**Addendum No. 1**

**For Project No. ENG2303730652  
Lincoln SP Phase 5 – Park Entry Improvements  
Lincoln State Park  
Spencer County**

**ISSUED FROM: Engineering Division Dept. Natural Resources**

Lincoln Amphitheater – Phase 5 – Park Entry Improvements  
Lincoln City, IN  
LA23102

DEMOLITION PLAN  
SITE PLAN  
BASE BID  
SCALE: 1" = 30'

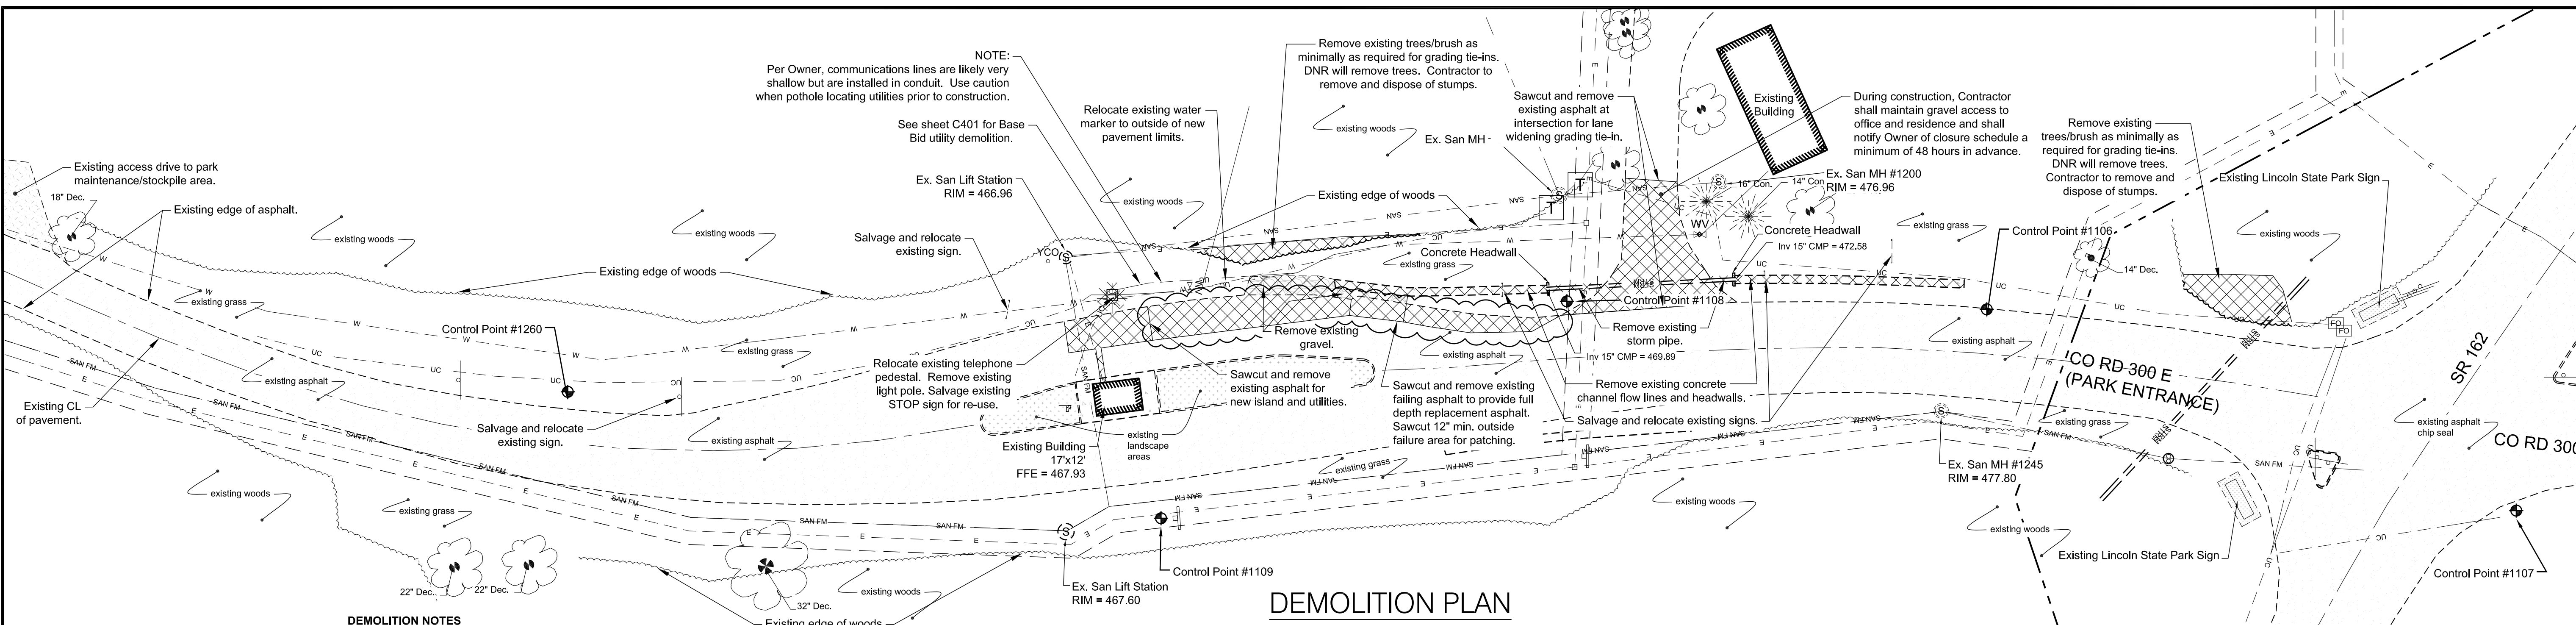
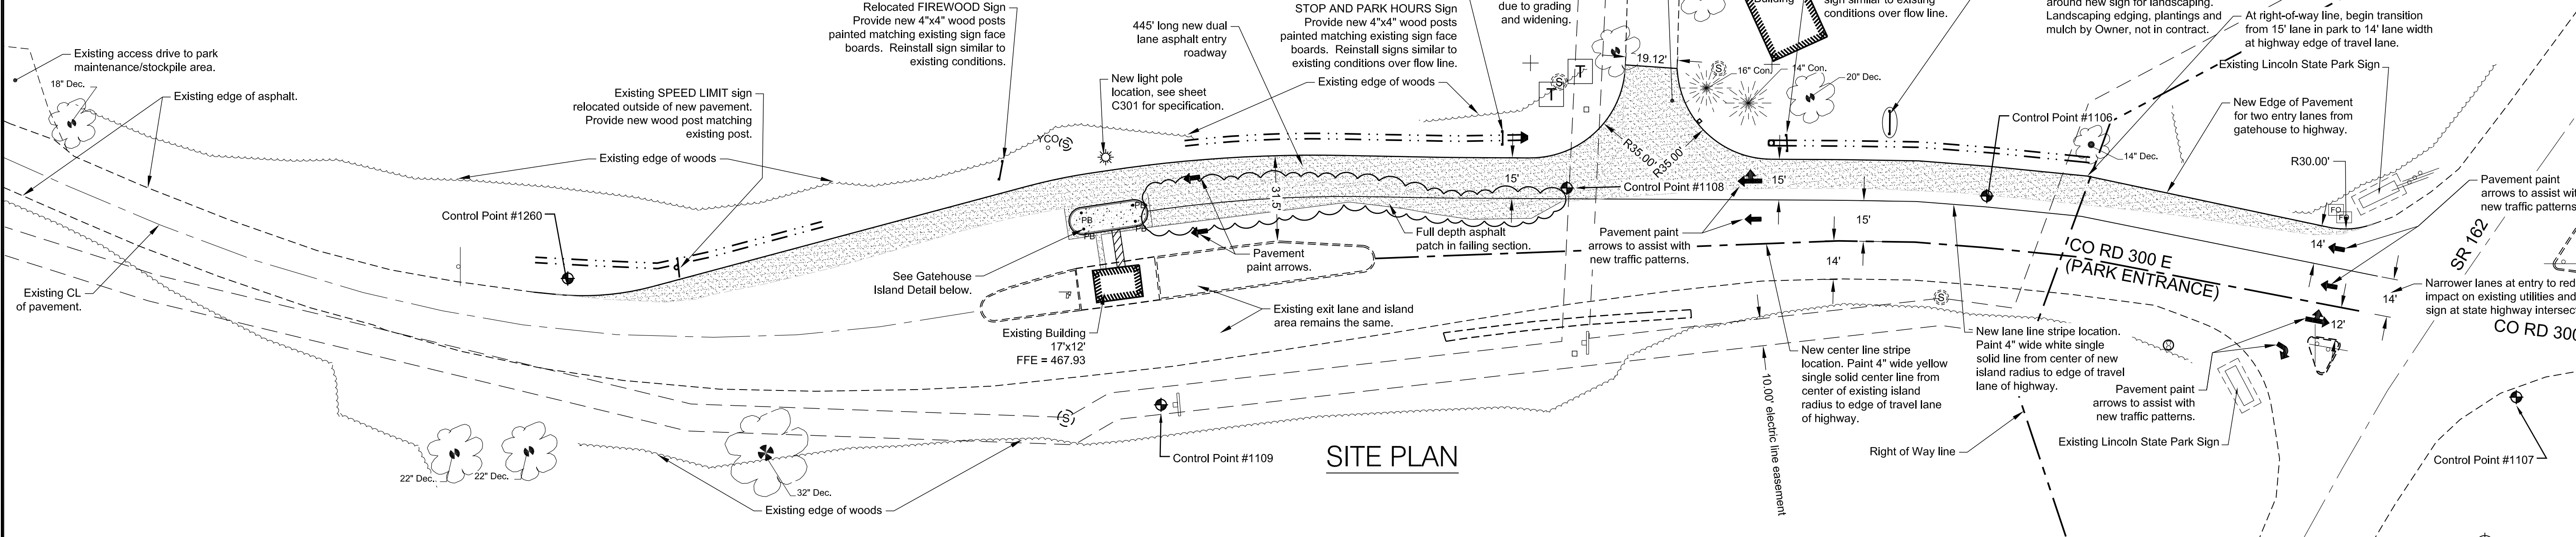
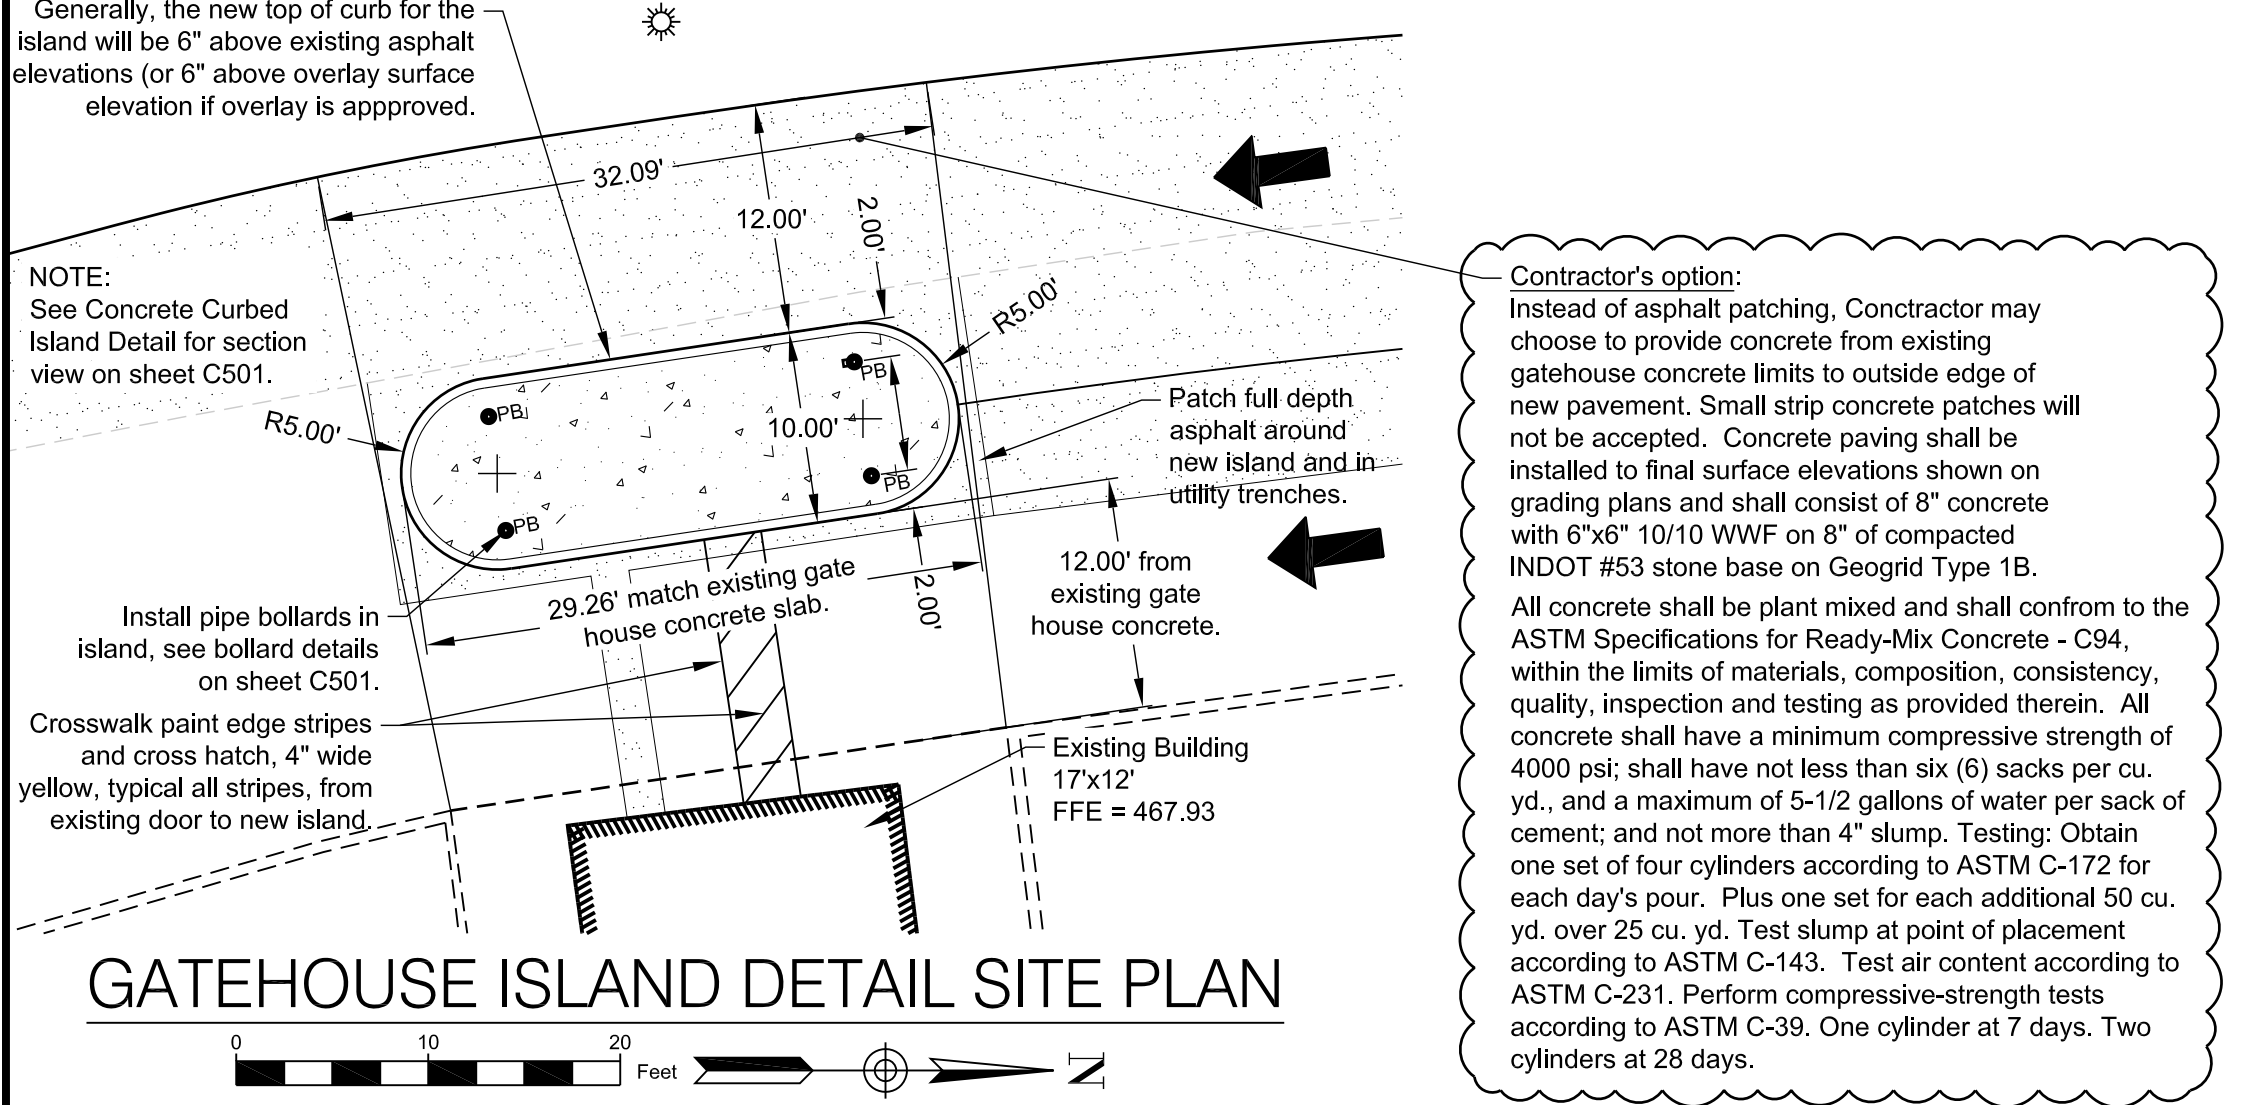
1. C201 has been revised to reflect the following items:
  - a. Added a contractor's option to use concrete for the full road lane width at the gatehouse island instead of asphalt patching utility trenches and around new island. Please note: If this option is selected by the contractor, the concrete shall match the full length of the existing gatehouse concrete pad and extend the full width of the road lanes to the new outside edge of pavement. Small strip concrete patching will not be accepted. Concrete specifications are now included on the plan sheet at the lower left corner.

- b. A specification change from #53 stone to **INDOT #53** stone was made for road base aggregate.
  - c. The BLSE CONTROL POINT data table was added to the sheet.

- d. Full depth patching limit was revised to include a larger area of failing pavement in both the Demolition Plan and the Site Plan on the sheet. At the Pre-Bid Meeting, the outside edge of the entry lane from gatehouse to the Park Office Drive is showing more failure than previous inspections indicated.

BLSE CONTROL POINTS	Point	Northing	Easting	Elevation	Description
	1106	1043298.873	2977243.426	478.25	MAG NAIL
	1107	1043290.027	2977323.843	482.45	MAG NAIL
	1108	1042939.778	2977246.482	471.86	MAG NAIL
	1109	1042790.046	2977326.47	467.92	5/8" IRON PIN WITH RED CAP "CONTROL POINT"
	1260	1042571.213	2977279.849	480.14	MAG NAIL

- PAVEMENT SPECIFICATIONS:**
- Entrance Widening Full Depth Asphalt Sections
  - 1.5" HMA surface Type B on 2.5" HMA Intermediate Type B on 6" HMA Base Type B on 6" compacted INDOT #53 stone base on Geogrid, Type 1B
